MerCruiser Service Bulletin

Official Notification U.S. Federal Boat Safety Act

MCM Shift Plate Cable Attaching Hardware

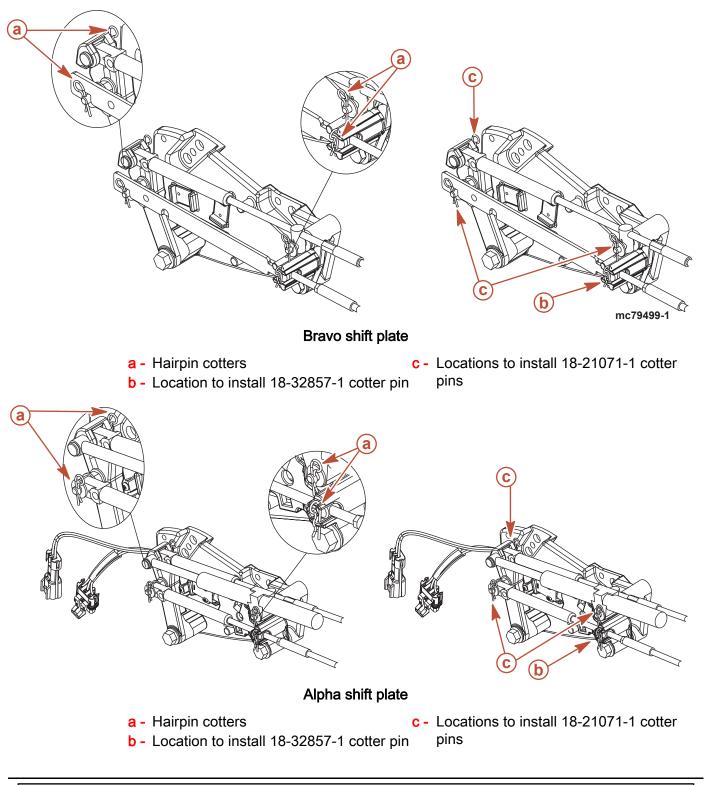
All affected MCM engines have a new shift plate assembly installed. These assemblies have a hairpin cotter for the shift cable attaching hardware that may come loose and fall out. The hairpin cotters that retain the shift cables to the studs and shift lever clevis pin on the shift plate assembly on all affected MCM engines may be bent open and will come loose and fall out. If that occurs, the shift cable will become disconnected from the shift plate, which will cause a loss of shift control.

Remove hairpin cotters (a) 18-859746 from all anchor points on the shift plate, and replace with (1) of 18-32857-1 cotter pin at the shift cable anchor on the Alpha switch actuating arm and Bravo shift cable retainer plus (3) of 18-21071-1 on the two studs and the clevis pin on the shift lever.
